Access Compliance Report Public Rights-of-Way (Curb Ramps)

Intersection ID: 10024053 Main Street: CORONATION BV Cross Street: N/A Location: Ε Initial Pass/Fail: Fail **Overall Compliance: No Severity Score:** 12.5 ADA ID: AE718EF138EF Ramp Type: PerpDiag

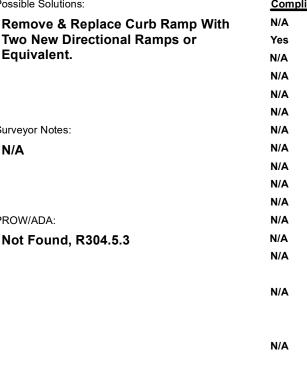
Not Found, R304.5.3

Two New Directional Ramps or

N/A 3200.00
